UK Offshore Energy Strategic Environmental Assessment

Consultation Feedback

UK Offshore Energy Strategic Environmental Assessment Future Leasing/Licensing for Offshore Renewable Energy, Offshore Oil & Gas and Gas Storage and Associated Infrastructure

Figure 5.81: Offshore wind: seafloor area remaining following application of “hard” constraints (10-60m) – refer to Table 5.35

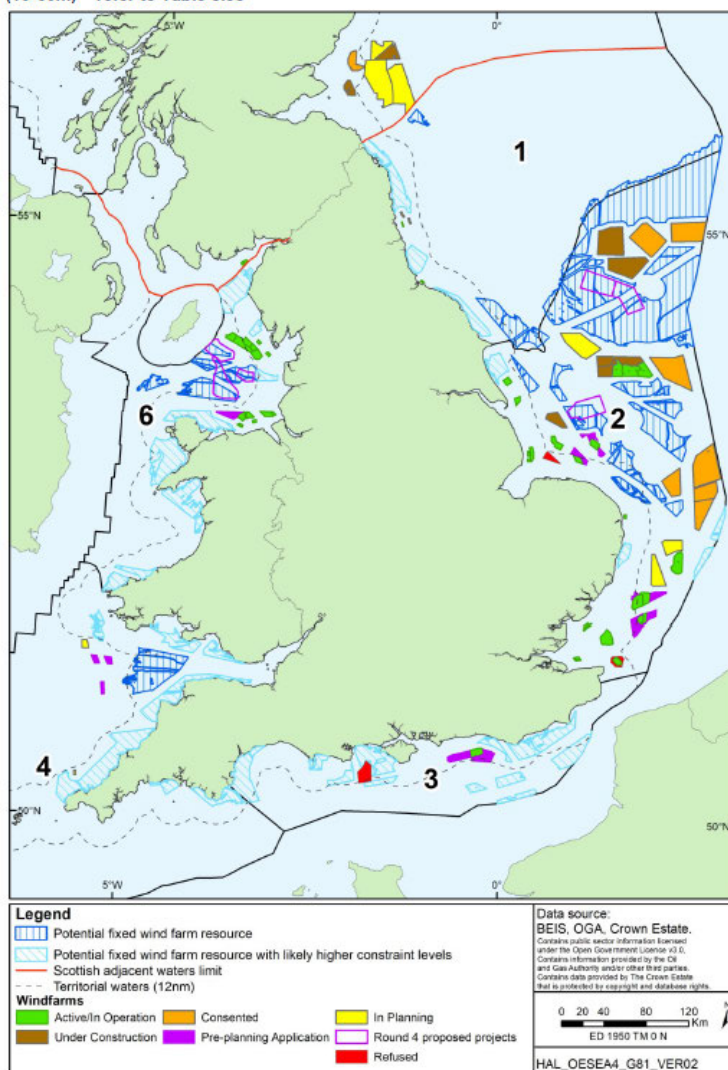
1. De ontwikkeling van vaste windmolenparken gebaseerd op een verscheidenheid aan beperkingen opgelegd zoals veiligheidszones rond infrastructuur, vaarroutes, visserij, mariene leidingen, mariene conservatie zone e.d.
 - a. Donkerblauw gearceerd: potentieel gebied voor de ontwikkeling van vaste windmolenparken
 - b. Lichtblauw gearceerd: potentieel gebied voor de ontwikkeling van vaste windmolenparken waar meer beperkingen kunnen opgelegd worden
 - c. Groen: actuele actieve windmolenparken
 - d. Oranje: goedgekeurd om te ontwikkelen, maar waar de ontwikkelaar wacht tot het economisch rendabel is (vraag naar hernieuwbare energie hoog genoeg)
 - e. Geel: ontwikkeling van windmolenparken in planning zijn
 - f. Bruin: windmolenparken in aanbouw
 - g. Paars: windmolenparken in pre-planningsfase of conceptfase
 - h. Rood: geweigerde windmolenparken

Figure 5.87: Offshore wind: seafloor area remaining following application of “hard” constraints (50-200m) – refer to Table 5.35

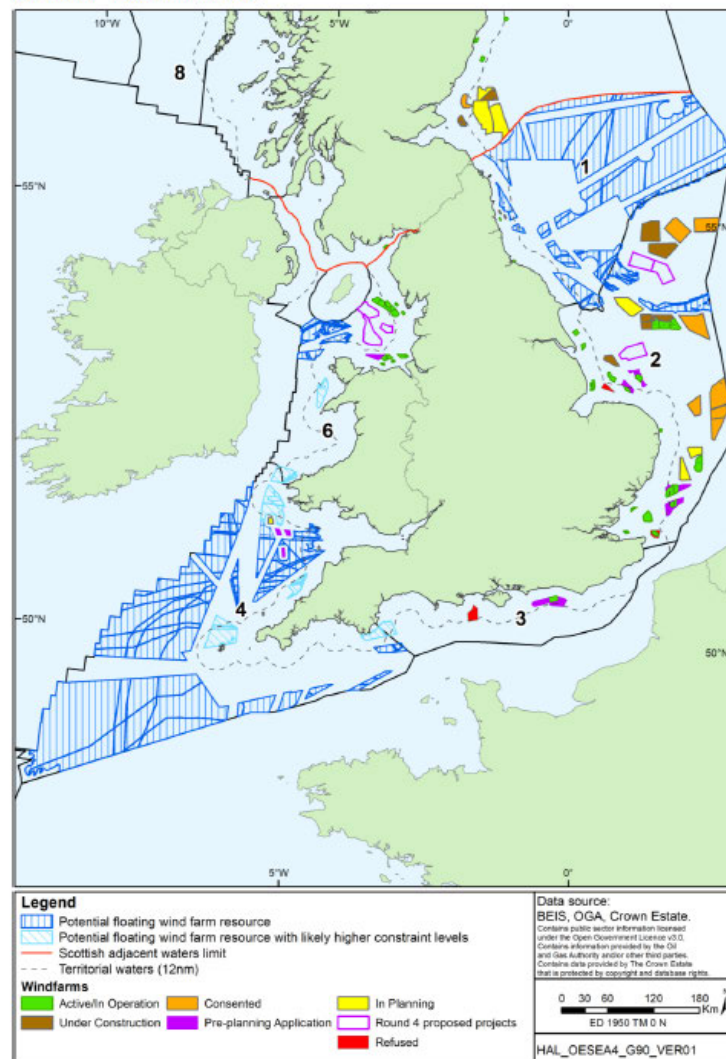
2. De ontwikkeling van drijvende windmolenparken gebaseerd op een verscheidenheid aan beperkingen opgelegd zoals veiligheidszones rond infrastructuur, vaarroutes, visserij, mariene leidingen, mariene conservatie zone e.d.:
 - a. Donkerblauw gearceerd: potentieel gebied voor de ontwikkeling van drijvende windmolenparken
 - b. Lichtblauw gearceerd: potentieel gebied voor de ontwikkeling van drijvende windmolenparken waar meer beperkingen kunnen opgelegd worden

Figure 5.92: Wave: seafloor area remaining following application of “hard” constraints

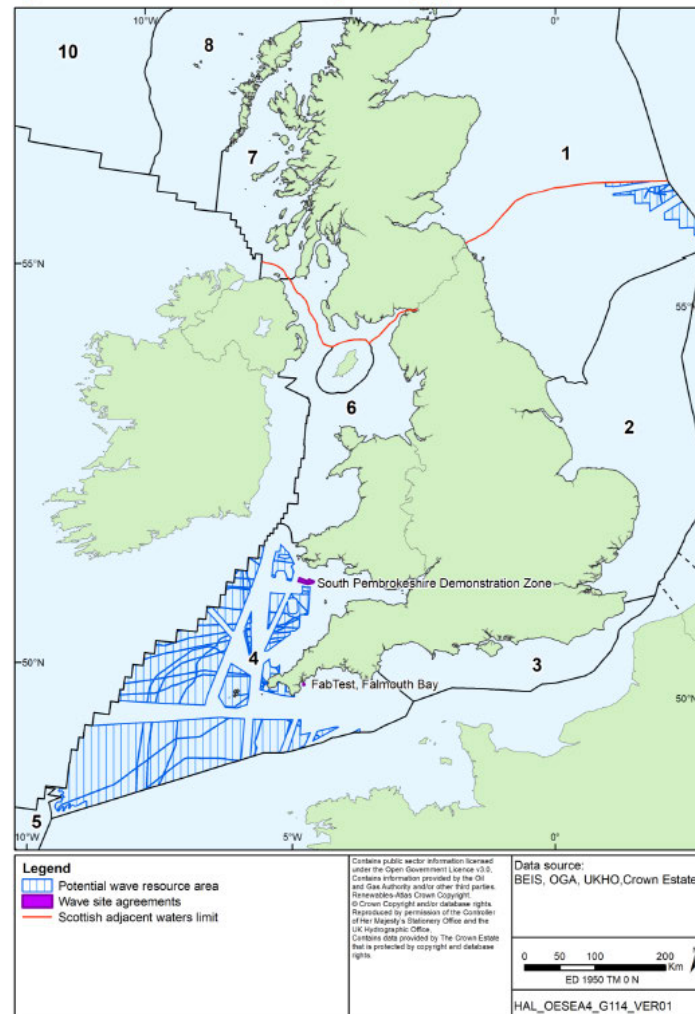
3. Golf- en getijdenenergie:
